ERRATA

PTI DC10.3-20 Design, Construction, and Maintenance of Post-Tensioned Concrete Courts

Second Edition, First Printing, September 2020

DC-10 Slab-on-Ground Committee

Page 62, Section 16.0 – EXAMPLE PLANS, Fig. 16 (a) – Layout of post-tensioning tendons in single court.

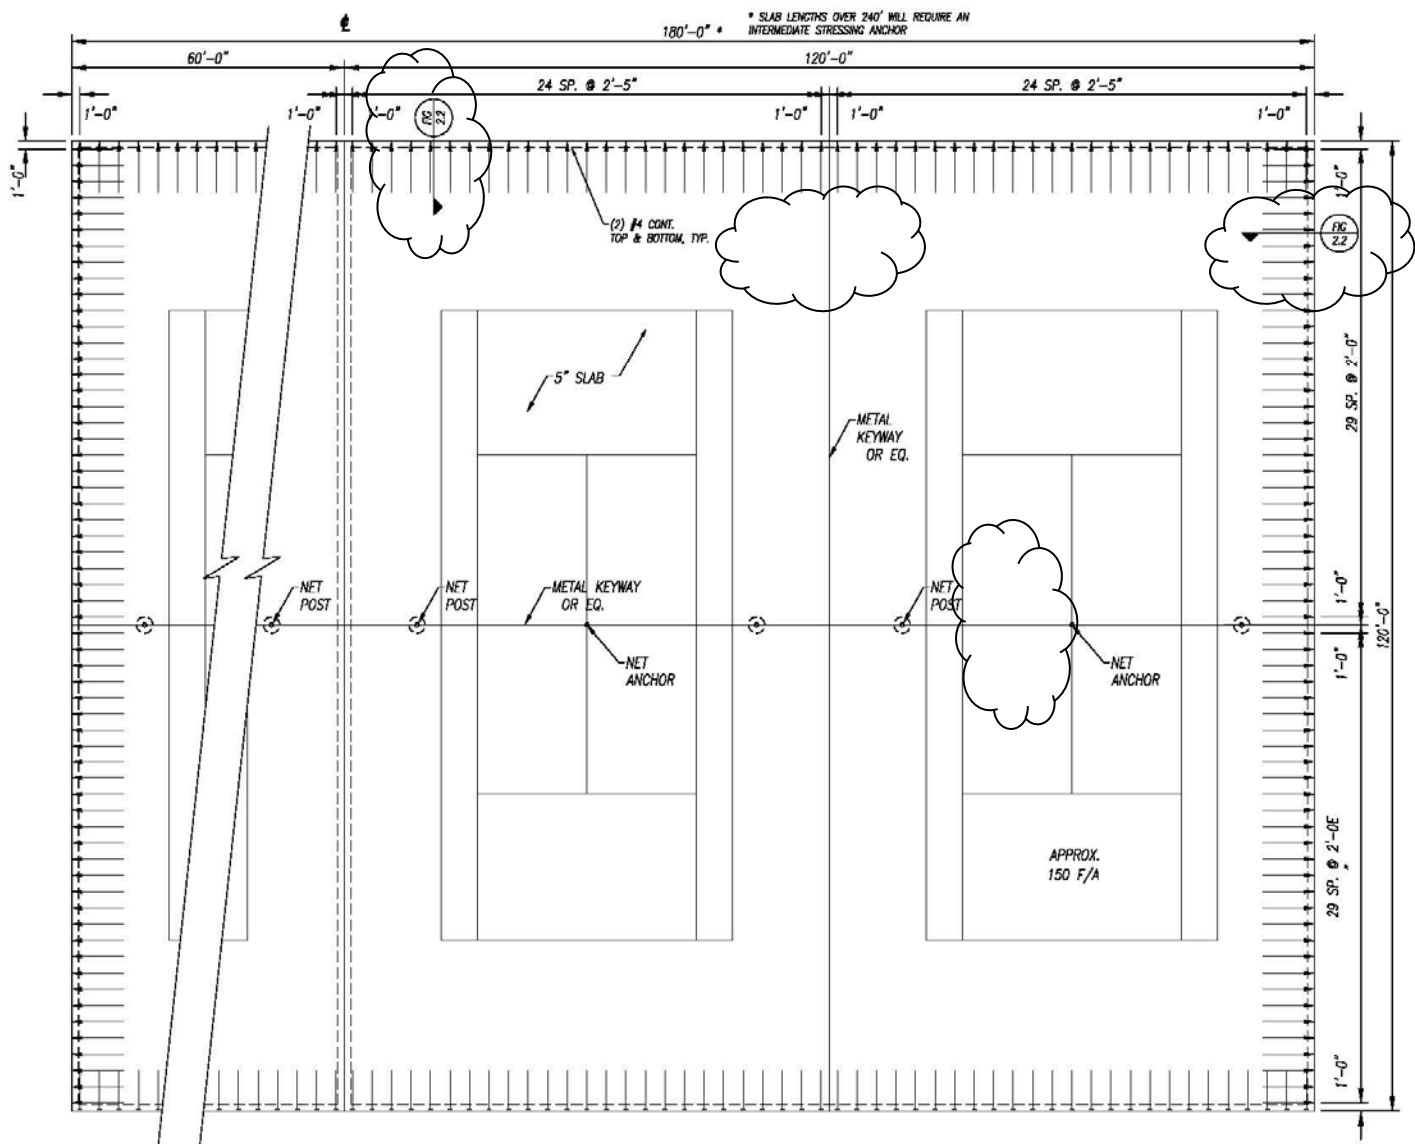
Change section references from Fig. 3.5 to Fig. 2.2.

Delete section cut Fig. XXX.
